TREES & CONSTRUCTION MEMO

To: Paul Bosveld
From: Bob Layton
CC: Heather Crain, Matt Wittman
Date: March 31, 2022; Updated August 20, 2022
Re: Tree Protection at 7345 SE 38th Street, Project 2110-193

The purpose of this memo report is to address the comments from the City regarding the protection of impacted trees. These comments are individually addressed as follows:

Photo Documentation

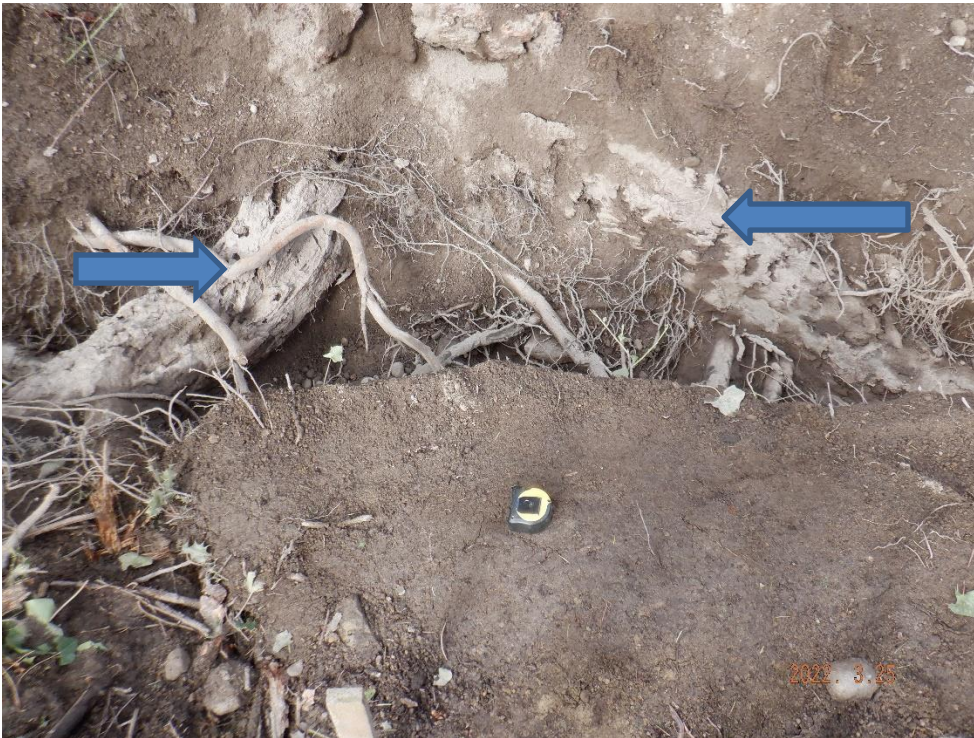
The buttress root locations of Tree #23 were air-excavated near the two closest proposed footings. See pictures below. The concrete footing proposed directly 4-feet east of the trunk face sits between the two exposed buttress roots which radiate away from the footing location. I believe this footing could have been hand-dug and poured without harming the tree; however, to provide more clearance between ground work and the tree trunk, the two closest footings have been omitted from the plans. This will allow protection fencing to be moved out away from the trunk face. It will now be +/- 8-feet from the trunk face at the closest point. Large buttress roots are not expected to be found in the location of the two remaining footings.

A trench was also air-excavated at 14 ½-feet south of Tree #23 at the proposed cut in grade for the new house. Only one 2-inch diameter root was exposed. See picture below. This root can be cut at the excavation limit without having any impact on the health or stability of the tree.

Root crown of Tree #23, 10-inch diameter buttress on left, 12-inch diameter buttress on right (arrows).

Exposed roots east of #23, proposed footing locations (arrows), north buttress root runs farthest west along edge of trench and would not be impacted

Decayed root pictured above at edge of proposed footing, can be pruned away

Trench air-excavated south of #23 at proposed cut in grade

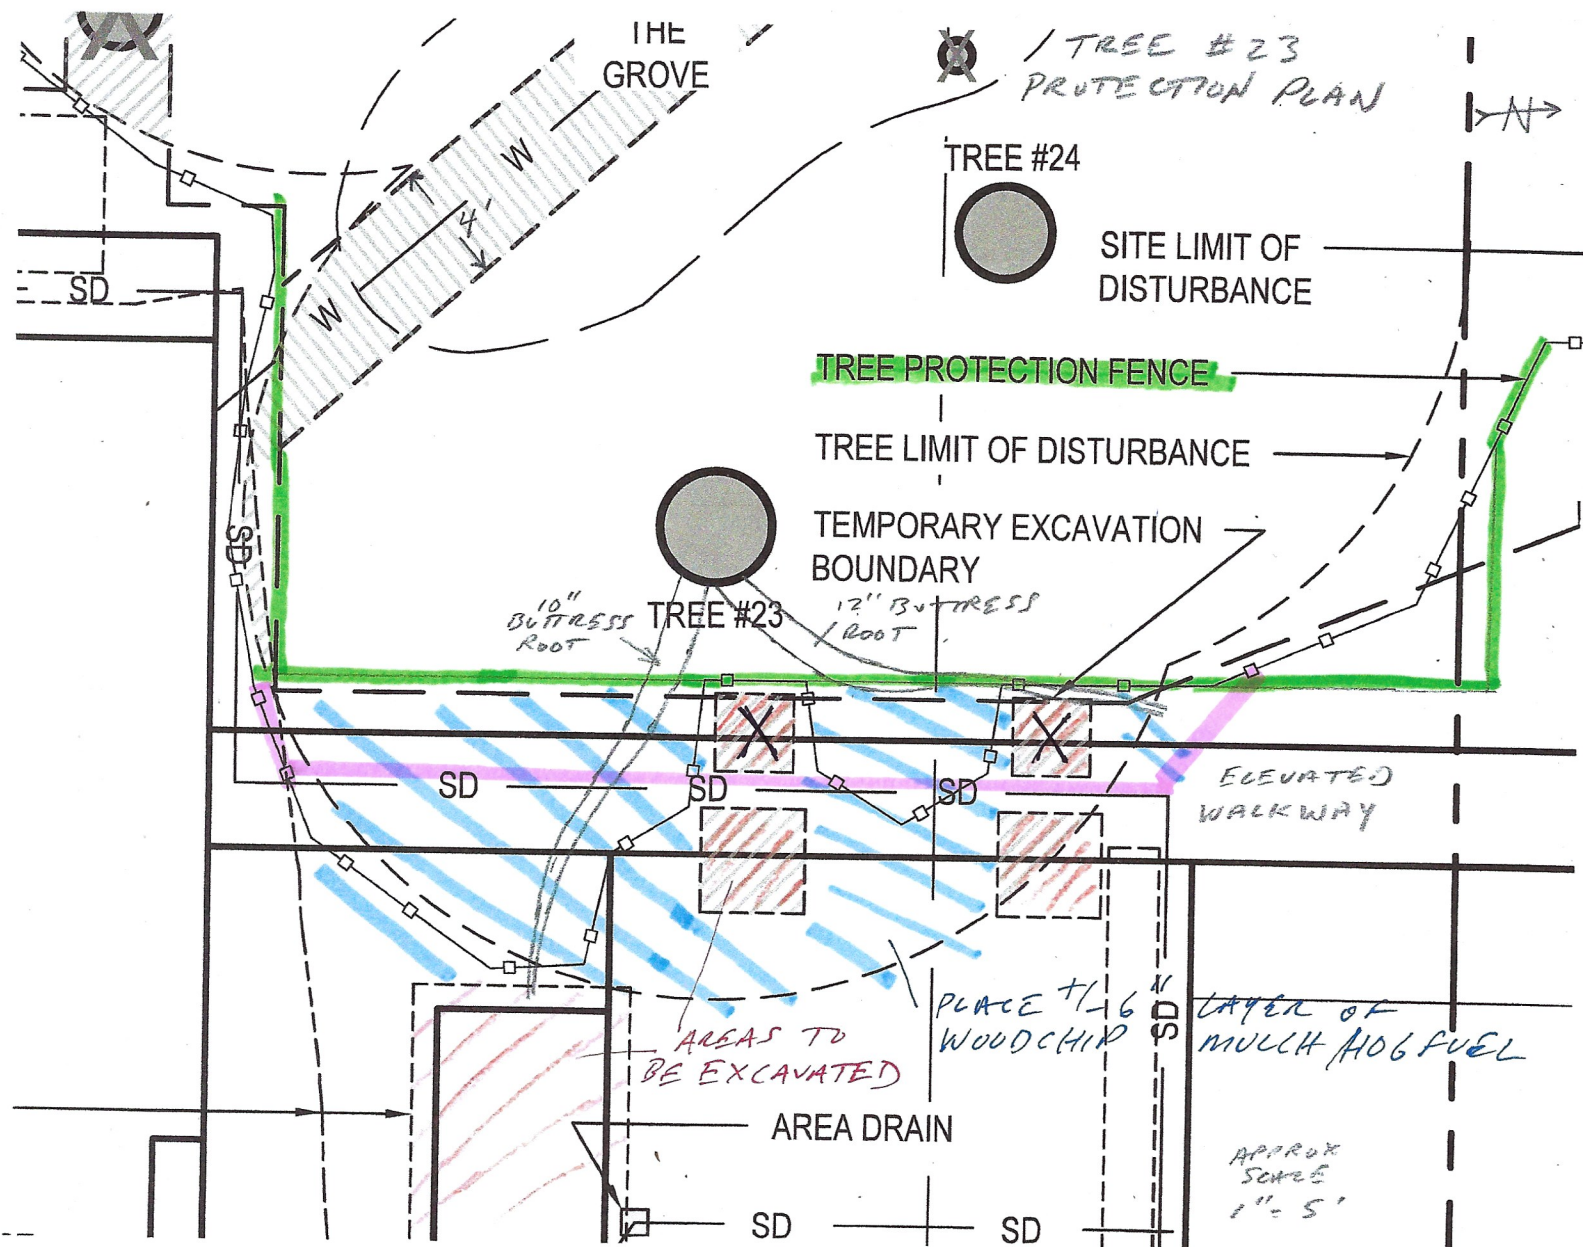
The two closest footings have been omitted from the plans allowing for 5-feet of clearance adjacent to Tree #23.

X - FOOTINGS TO BE OMITTED

— EXPAND PROTECTION FENCING

WATERLINE PLAN

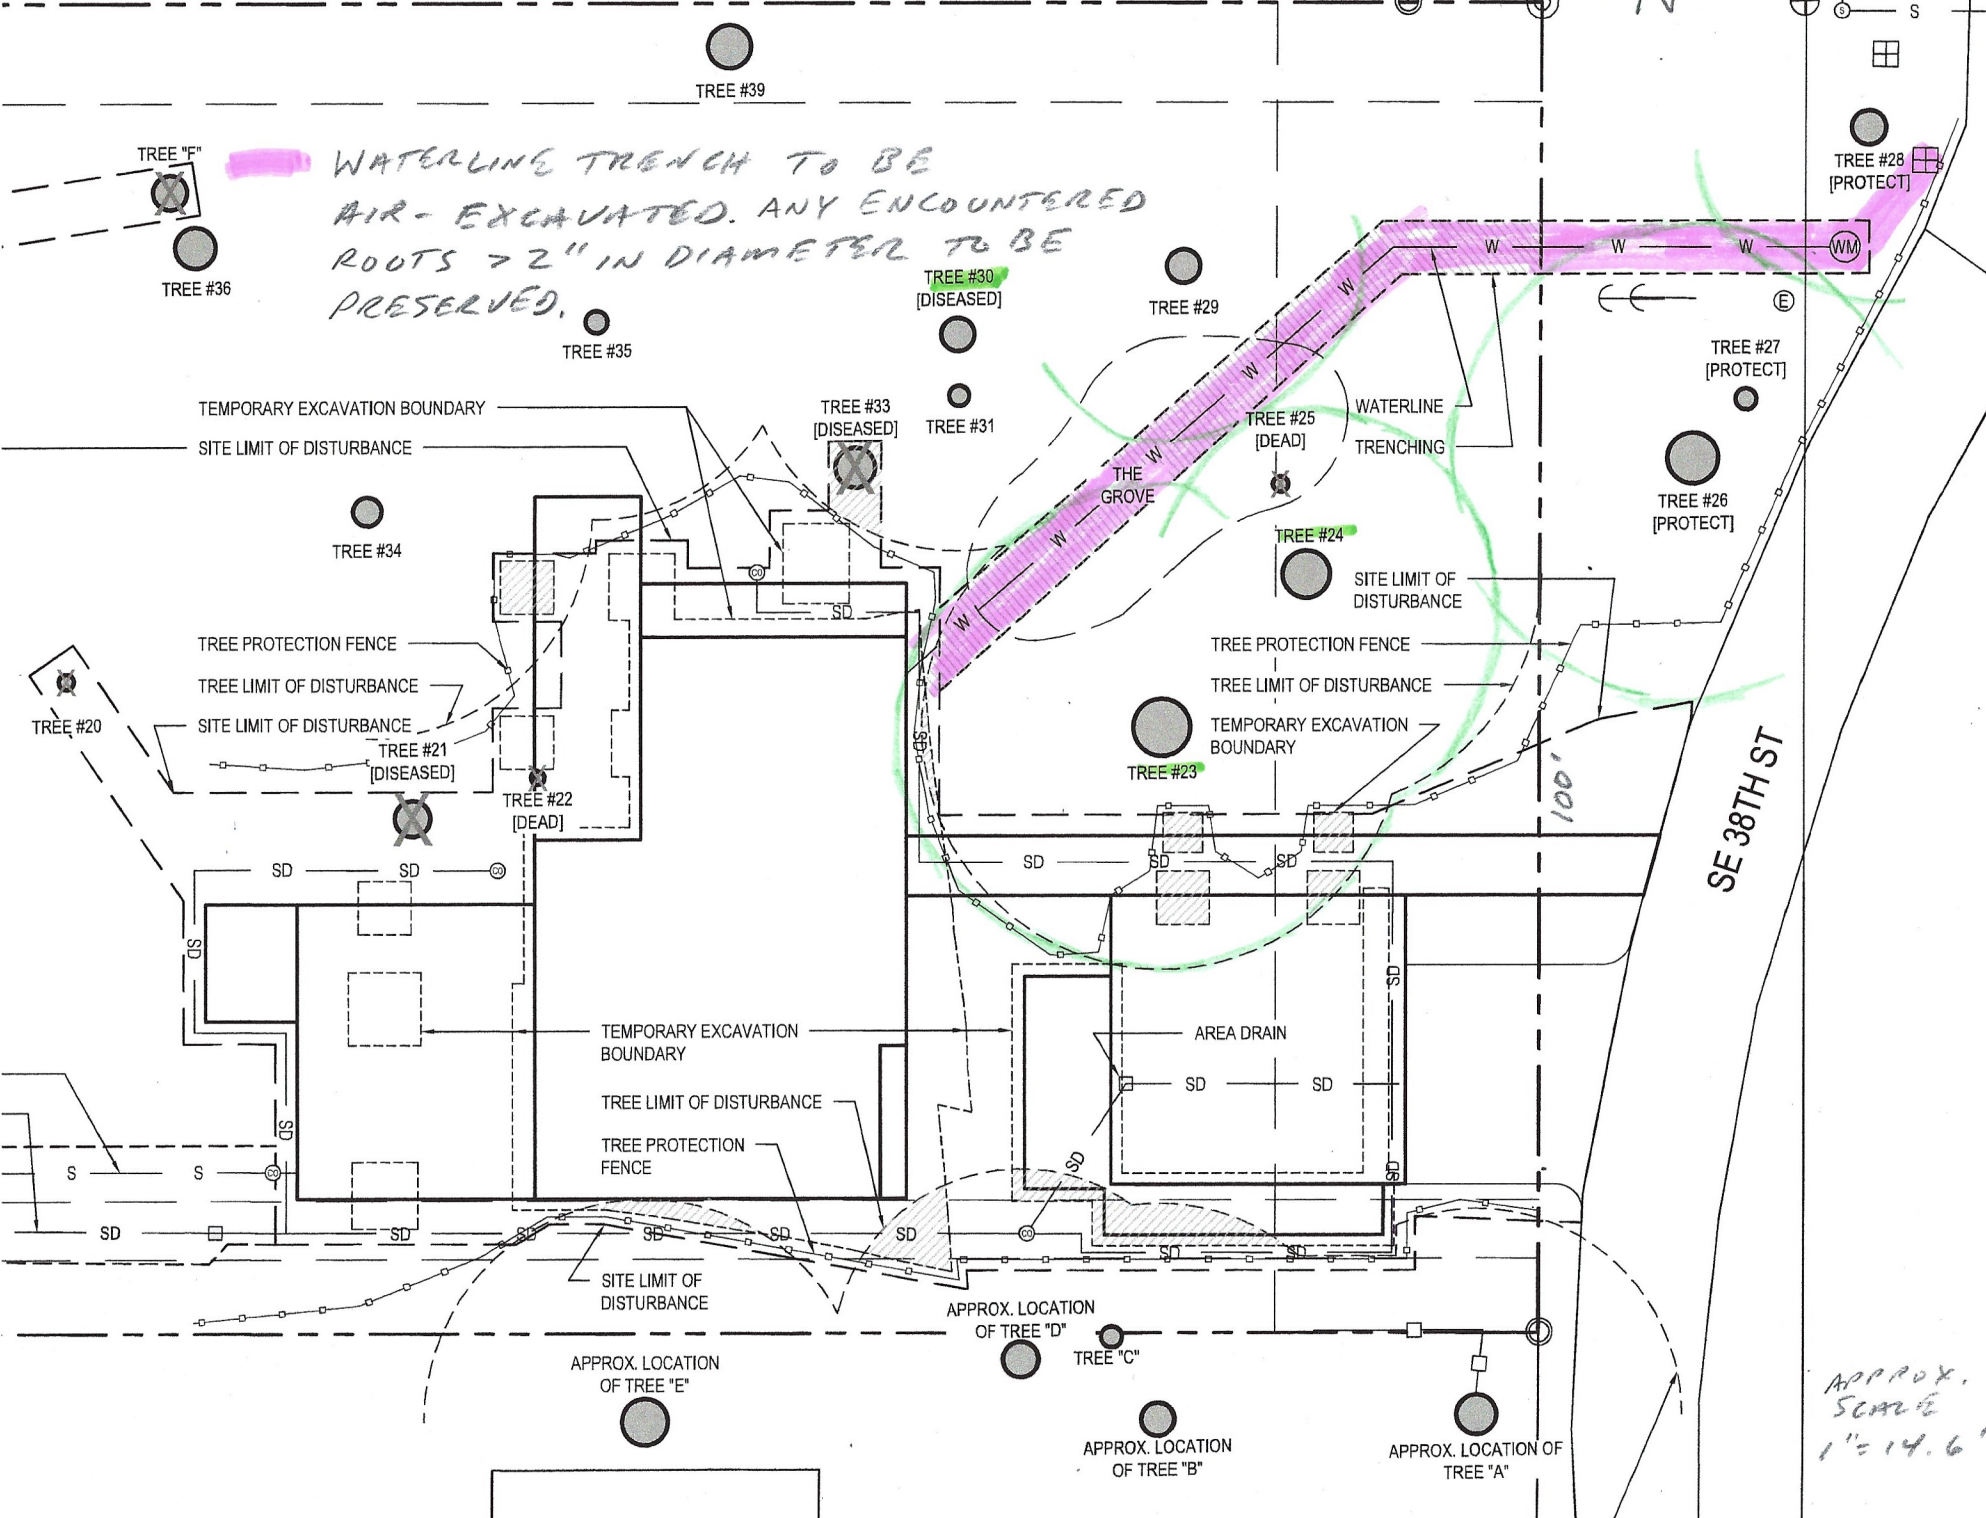
Given the number of exceptional trees to be retained within the vicinity of the water line utility, it is not possible to stay at least 12-feet away from all exceptional trees. The location of the trench will ultimately be field-located to be as far from exceptional trees as possible. The entire length of the water line trench will be air-excavated. All roots greater than 2-inches in diameter will be preserved and the utility/pipe routed beneath them. The trench location on the

attached map is shown as 4-feet in width. Realistically, the trench would only need to be a foot to a foot and a half wide to install the plastic waterline.

WATERLINE TRENCH TO BE AIR-EXCAVATED. ANY ENCOUNTERED ROOTS > 2" IN DIAMETER TO BE PRESERVED.

SOUTH UTILITY PLAN

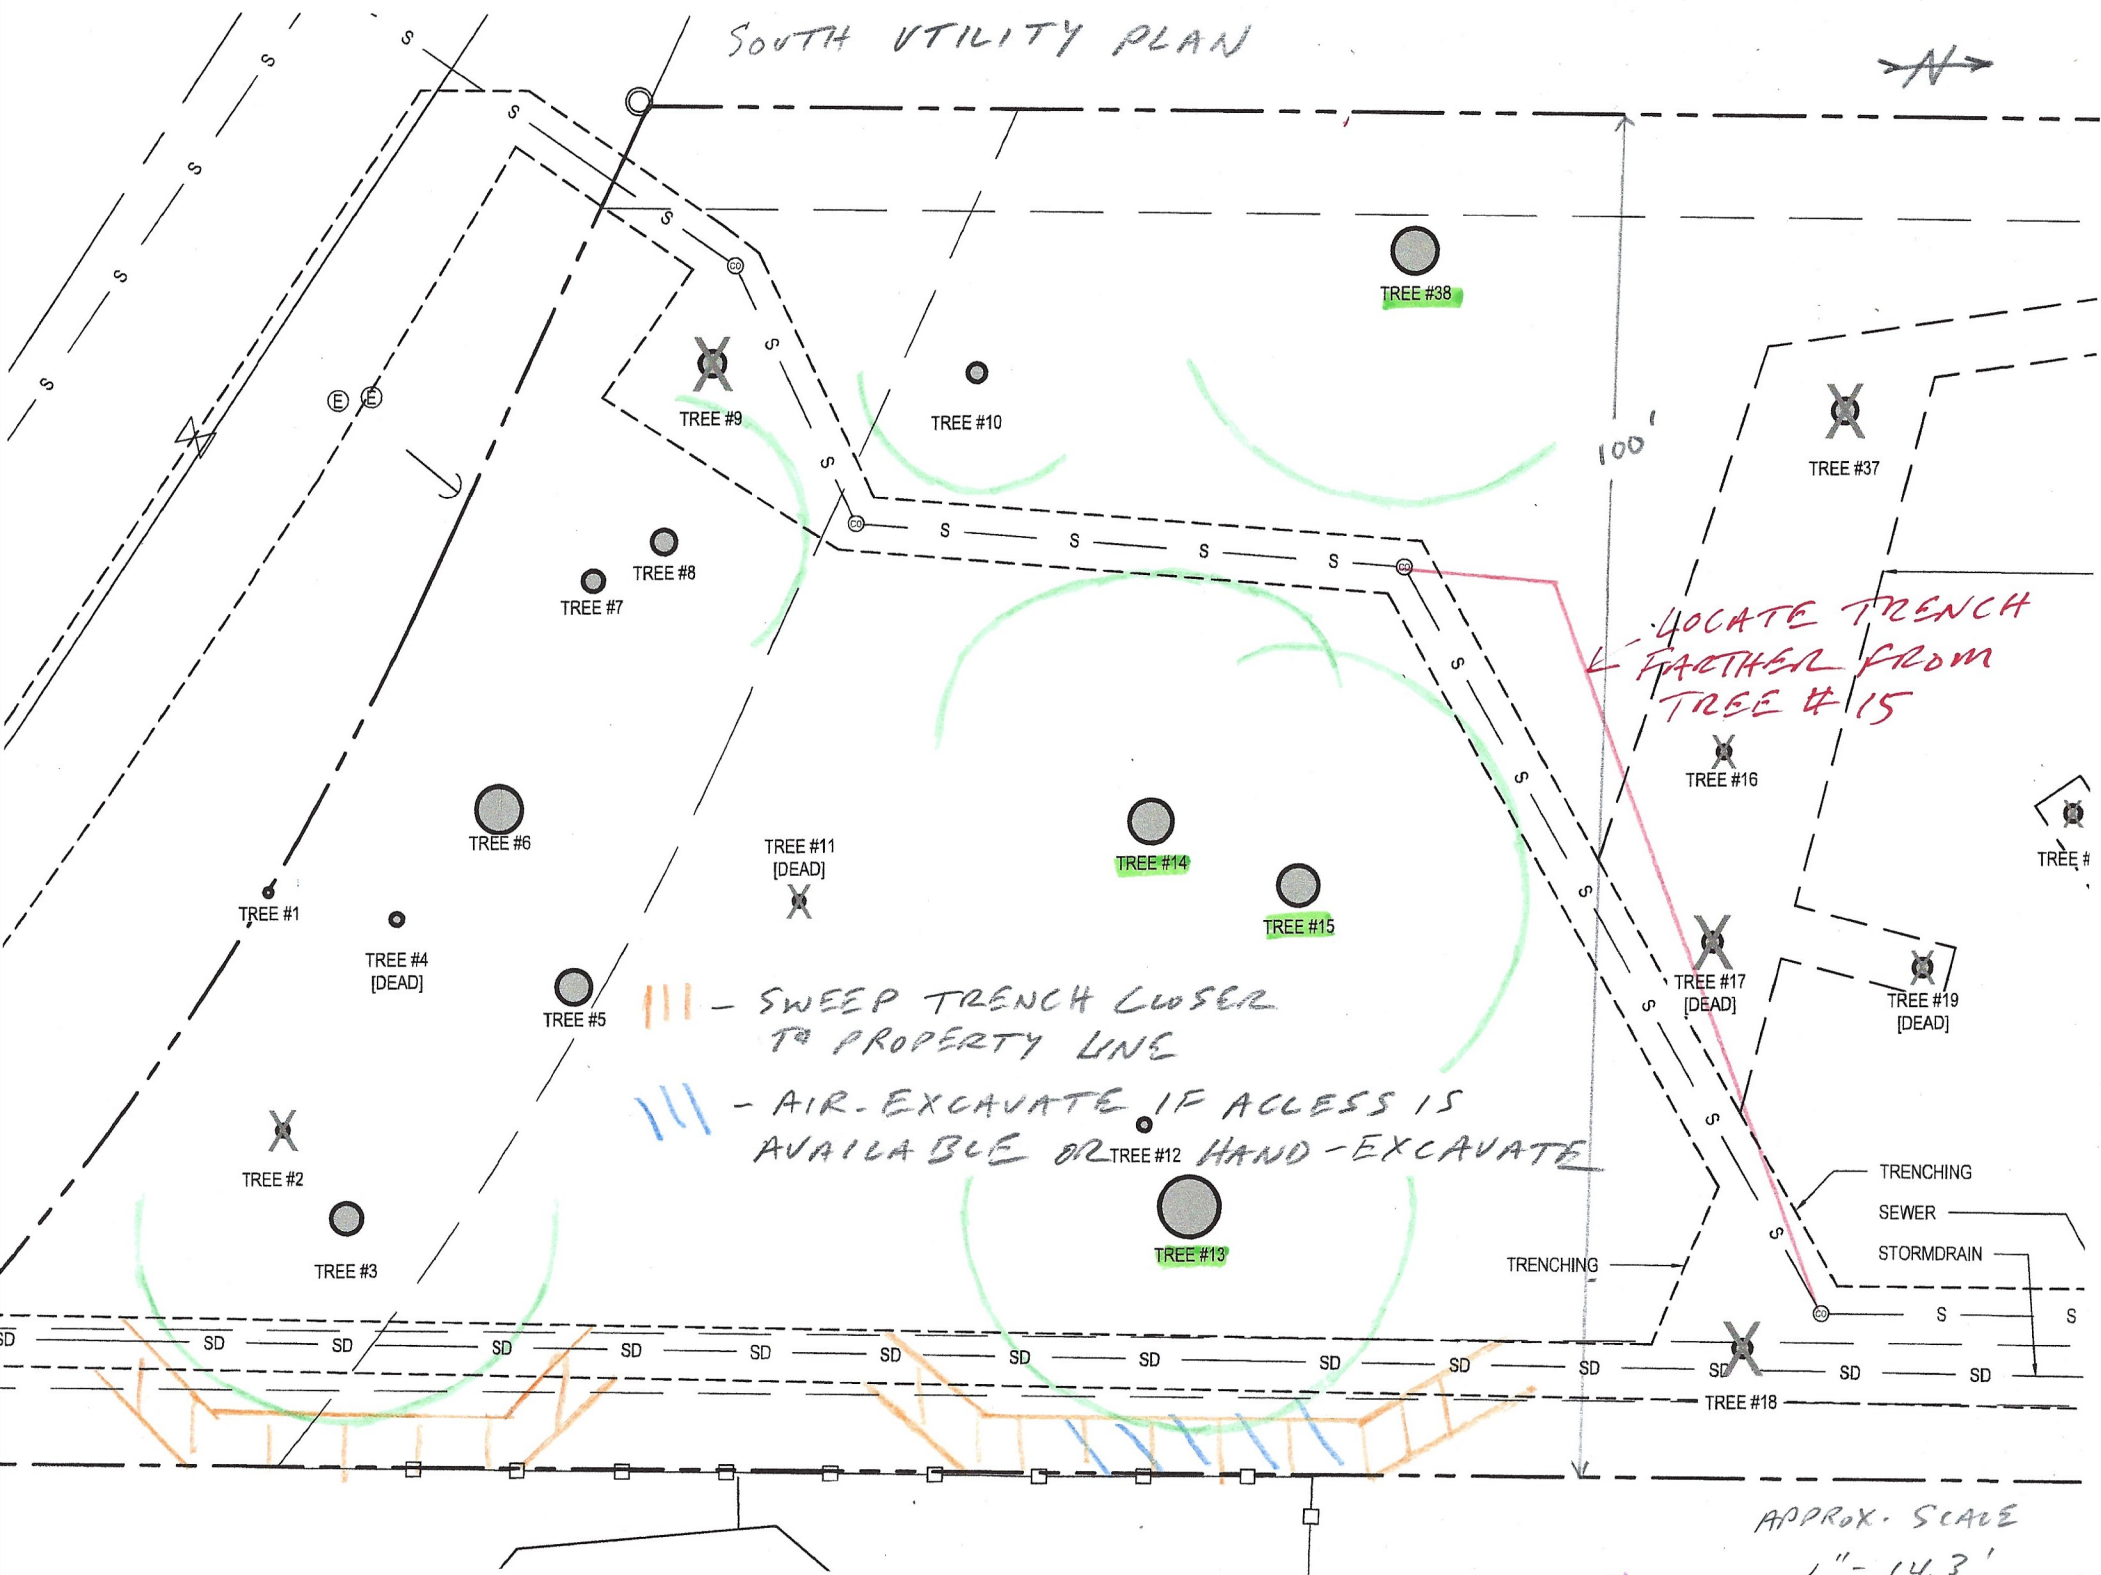
The sewer utility has been designed to avoid the driplines of adjacent trees. The storm drain utility on the south perimeter shall be moved closer to the property line to the farthest extent allowable to reduce the impact to Tree #13 and Tree #3. See the attached copy of the site plan. Slightly move trench north away from Tree #15. The majority of trenching can be accomplished with a tracked mini-excavator. Air-excavate adjacent to Tree #13 if access available or hand-excavate to preserve any roots greater than 2-inches in diameter.

LOCATE TRENCH
1' FARTHER FROM
TREE #15

SWEEP TRENCH CLOSER
TO PROPERTY LINE

AIR-EXCAVATE IF ACCESS IS
AVAILABLE OR TREE #12 HAND-EXCAVATE
